Parcel 2 Concept Plan Review

19 July 2023

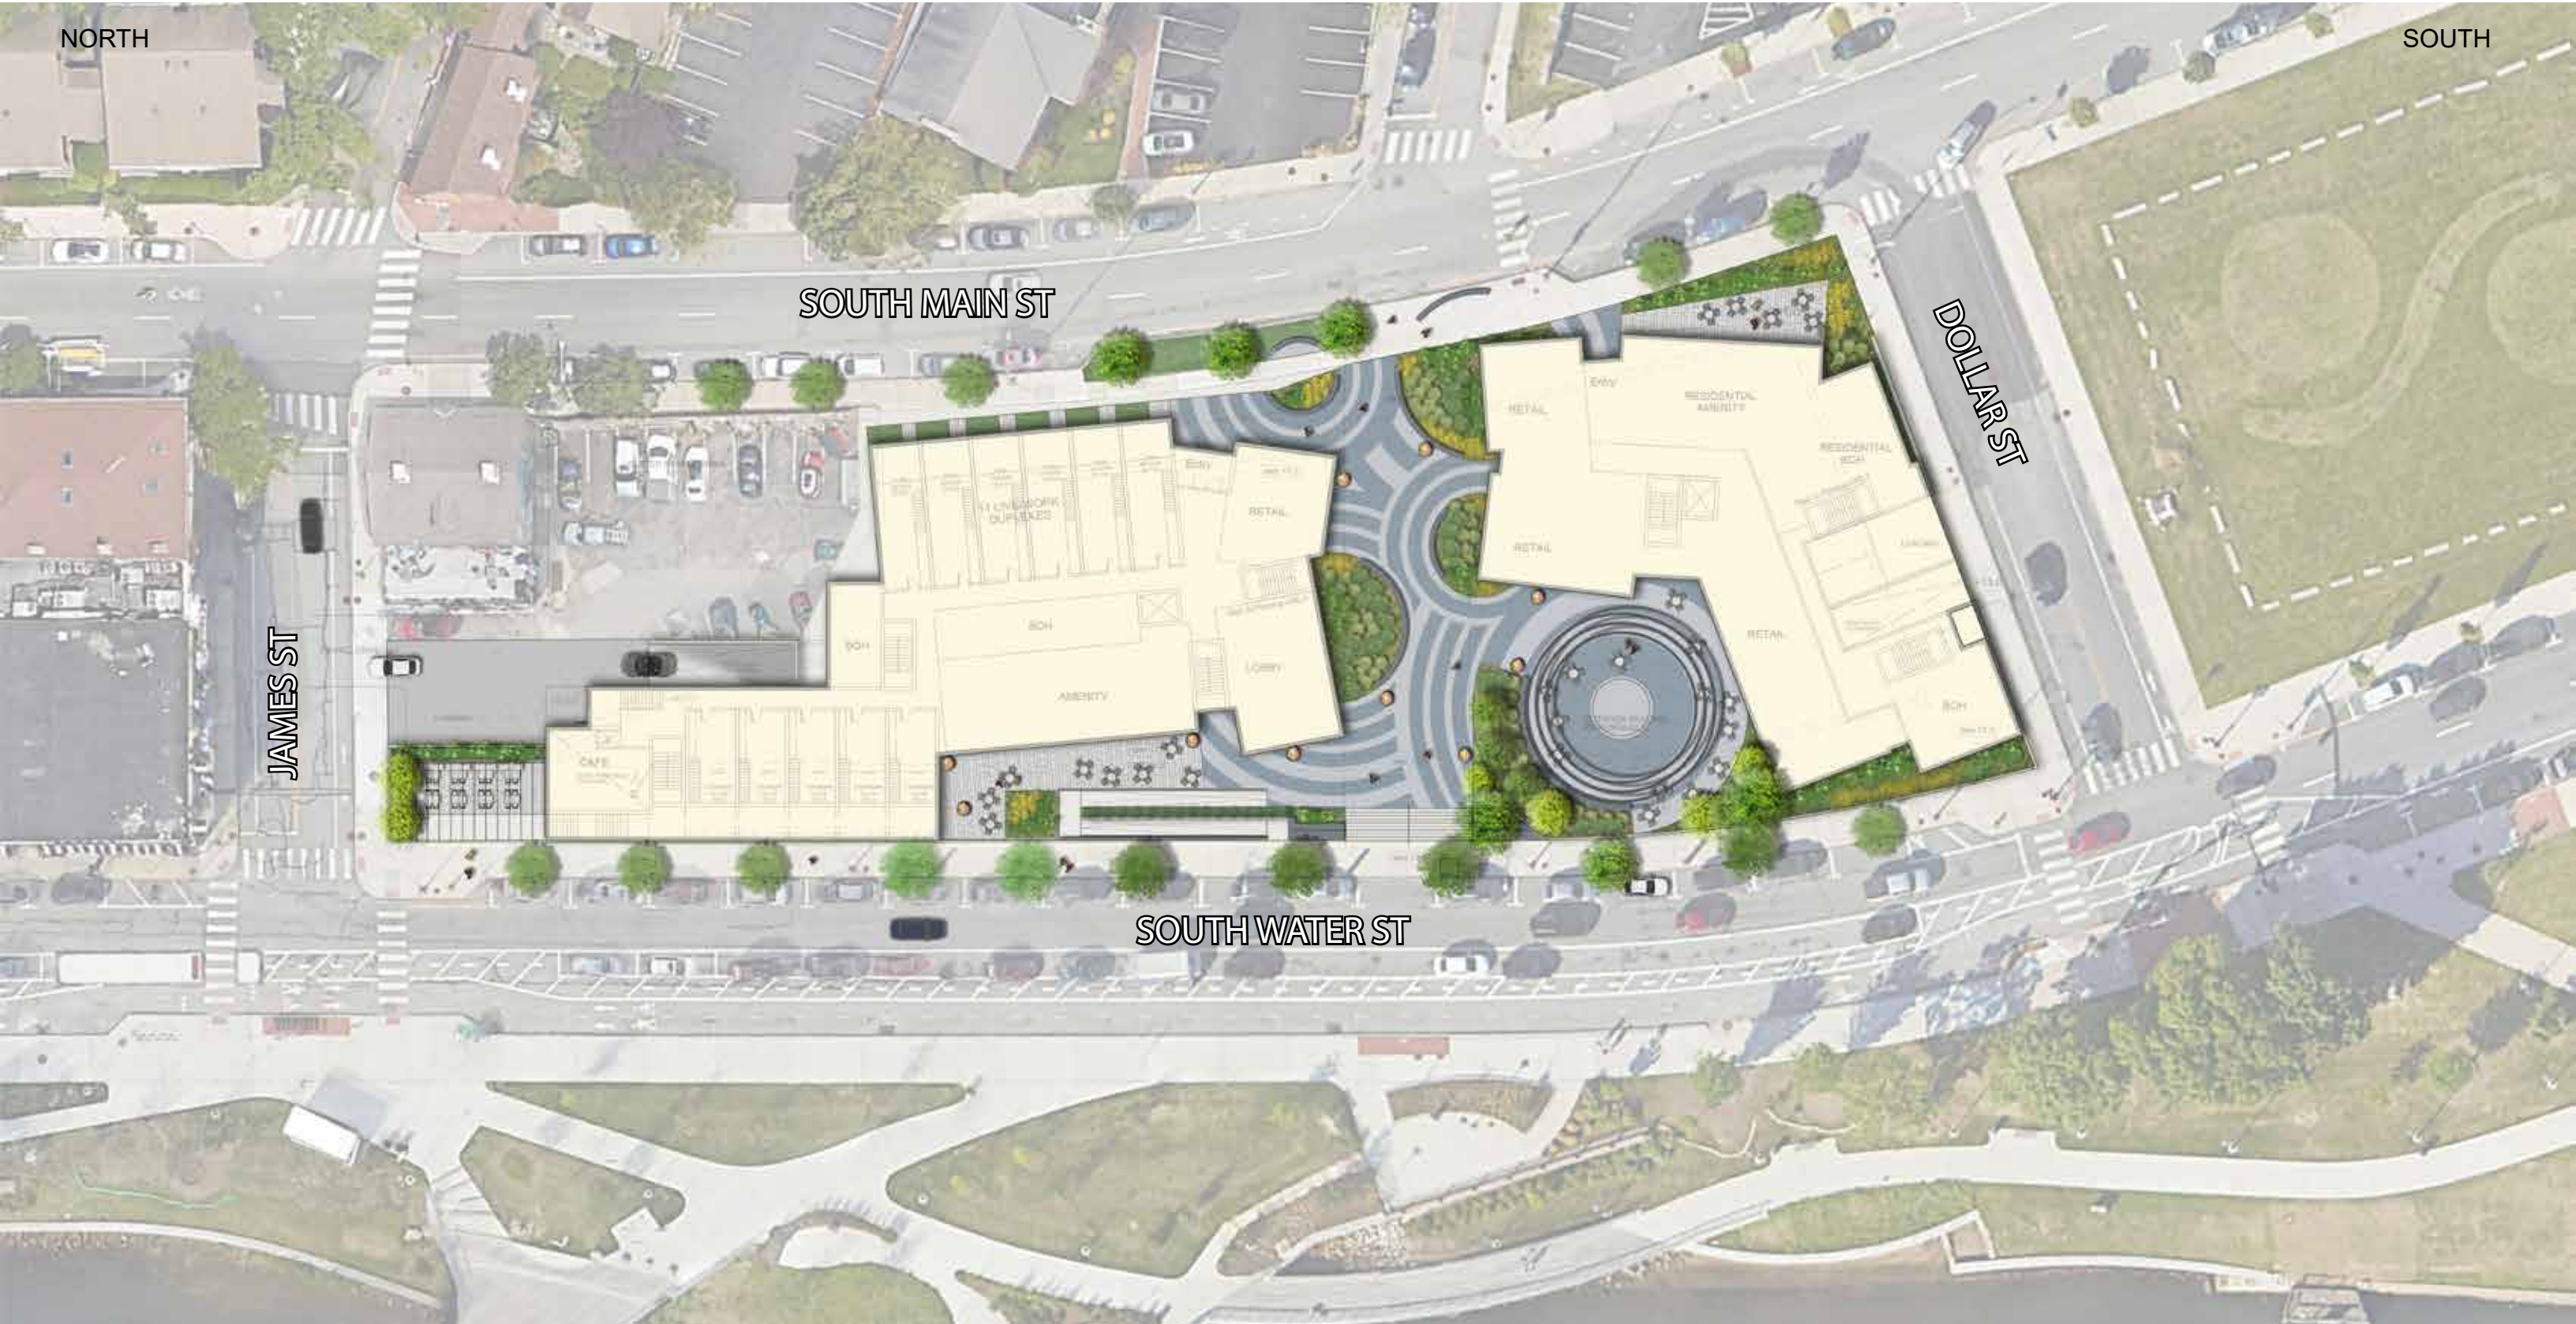
3. The piers would benefit from a more unified resolution at the top of the building. This could, for example, be addressed through a unified cornice line.

See this building precedent (on the right) with pier expression extending to the top of the building. There is some articulation at the roofline, but not an overhanging cornice.

In the case of some newer buildings, cornices can sometimes appear to be forced, superficial add-ons.

I DO NOT AGREE WITH THIS.

Earlier Scheme

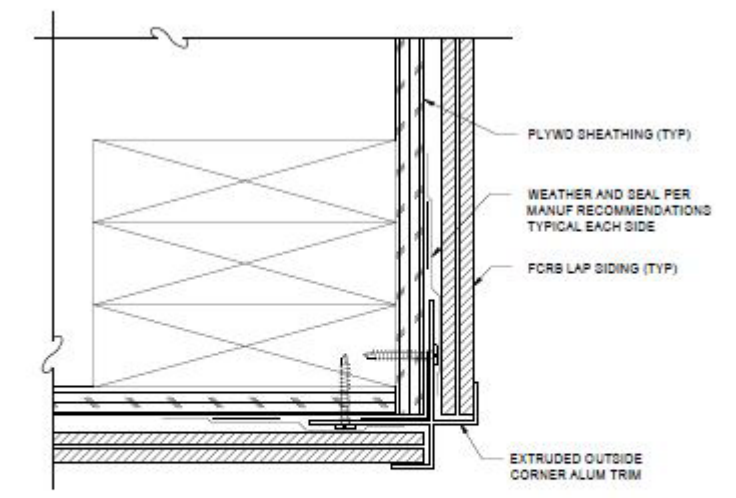
4. The spatial definition of the corner plaza at James Street and South Water Street should be strengthened in order to hold the corner with more strength and confidence. The current scheme is overly deferential to the rear facade of the historic building.

CURRENT PROPOSAL: Massing & Building Expression

-piers are extended to the ground, extra volume added to address proportion

1
A4.02 EXTERIOR SIDING: DETAIL
SCALE: 6"=1'-0"

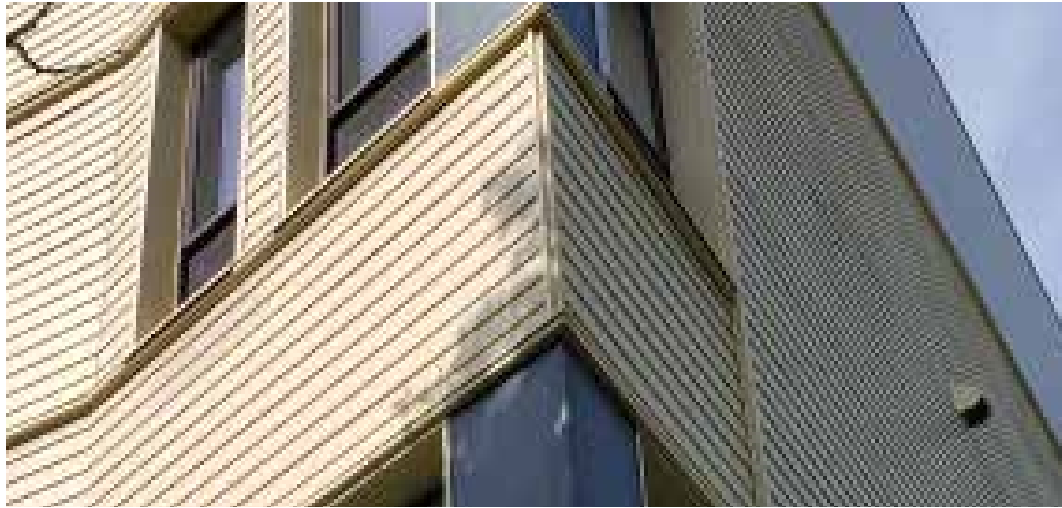
CURRENT PROPOSAL: Facade Design

-precedent for joint at terra cotta shingles

We propose to use a two L-shaped pieces of aluminum trim- in essence which form an "X" at the corners. The terra cotta shingles will butt directly into the corner joint. We will then paint the trim to match the shingle color. We used this system at our Parcel U project in Jamaica Plain (with fibercement panels.)
